February 28, 2022  
E-60264

**Subject:** Response to Request for Additional Information for Application for Revision 6 of Certificate of Compliance No. 9358 for the Model No. TN-LC, Docket No. 71-9358

**Chapter 2 - Structural Evaluation:****RAI 2-1:**

**Figure RAI 2-1-1**  
**Fuel Compartment Square Boundary (not to scale)**

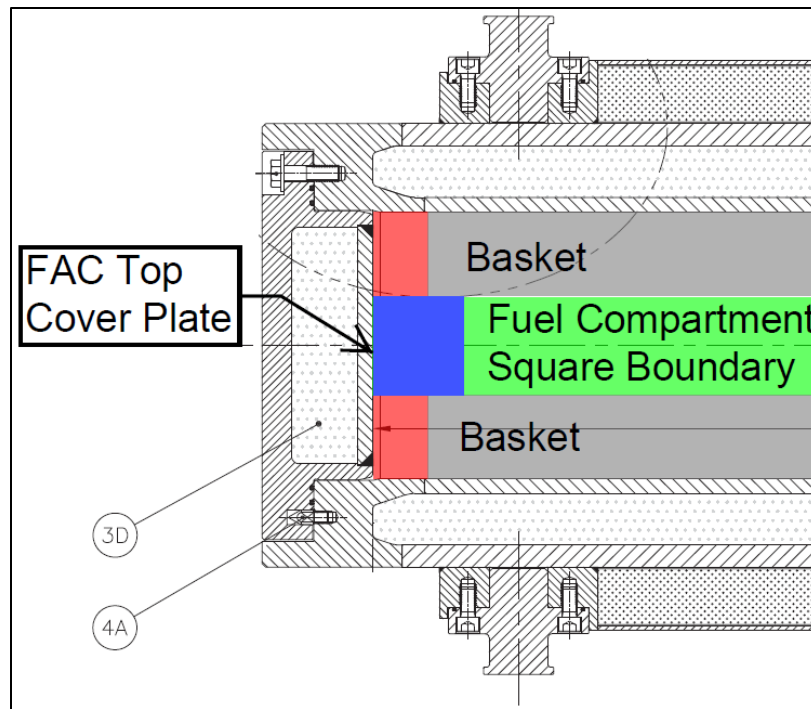
Evaluate applicable Normal Conditions of Transport (NCT) and Hypothetical Accident Conditions (HAC) scenarios for the Fuel Assembly Can (FAC).

In Section 1.4.5.2 of the application, the applicant discussed the TN-LC-1FA Basket contents which includes the new damaged fuel assembly can (FAC) intended for use with damaged fuel assemblies. The applicant only addressed thermal expansion of the FAC in this amendment request, particularly in Section 2.13.10.2 of the application. The staff could not find any additional evaluations for NCT or HAC for the FAC or a justification why it remains bounded by other analyses already performed.

It is not clear to the staff how the FAC will behave under NCT and HAC scenarios, mainly drop events. In particular, the applicant needs to clarify if impact loads have any effects (i.e., deformations) on the FAC which could then have potential effects on the fuel geometry and therefore on the criticality evaluations. The applicant needs to evaluate how the fuel assemblies, contained within the FAC, will continue to remain subcritical under the applicable NCT and HAC scenarios.

Per SAR Section 1.4.5.2.1, the thickness of the FAC top lid (Item 5 of Drawing 65200-71-91) is 1.25 inches, and the thickness of the bottom cover (Item 2 of Drawing 65200-71-91) is 1.25 inches (including the thickness of the bottom spacer bars), both of which are greater than the axial gap of 1.00 inch between the basket length of 181.50 inches and cask cavity length of 182.50 inches. Therefore, both top lid and bottom cover are always confined within the fuel compartment, and cannot move outside the fuel compartment on either end, regardless of the basket axial location within the cask cavity during NCT or HAC.

The top lid and bottom cover are design features of the packaging that ensure that any fuel material is always confined within the fuel compartment square boundary, and fuel material cannot be released outside the fuel compartment square boundary into the space between the 1FA basket and TN-LC inner cavity. Figure 2-1-1 shows the top of the cask, where the fuel compartment square boundary is shown in green, the basket is shown in grey, and the FAC top lid is shown in blue. No fuel material can be released into the volumes marked in red because of the presence of the FAC top cover plate. A similar configuration with a gap between the basket and inner cavity could exist at the bottom of the cask if the basket were to slide to contact the TN-LC lid.

The function of the top lid and bottom cover would be accomplished even in the event of a failure of the welds that connect the top lid (Item 5 of Drawing 65200-71-91) to the top lid centering liner (Item 4 of Drawing 65200-71-91), or of the weld that connects the bottom cover (Item 2 of Drawing 65200-71-91) to the liner (Item 1 of Drawing 65200-71-91), or of the liner itself. The thicknesses of the top lid and bottom cover alone without the liner are sufficient to achieve the intended function of the FAC. The liner with bottom cover is an operational feature to allow for fuel handling with the FAC attached to the fuel assembly. The top lid and bottom cover perform the safety function of confining fuel material within the 1FA basket fuel compartment, and the liner is not required for the contents to remain subcritical.

The liner is not important in keeping the top lid and bottom cover in place to achieve the intended function of the FAC during transportation. For side drops, both the top lid and bottom cover are self-supported and self-loaded. Also, both plates are not slender; therefore, there is no risk of buckling. For end drop on the lid, the top cover plate is loaded with the fuel assembly through bearing on the TN-LC lid. There is no deformation of the top lid that would allow debris to escape from the fuel compartment. For bottom end drop, the bottom cover of the FAC is loaded by the fuel assembly, which may lead to some deformation of the plate because the spacer bars provide a point of contact for bending. During an end drop or side drop the debris is restricted from escaping the fuel compartment. This ensures debris will not accumulate in the gap between the basket and TN-LC ends. Therefore, the top lid and bottom cover perform the intended safety function described above during both NCT and HAC impacts.
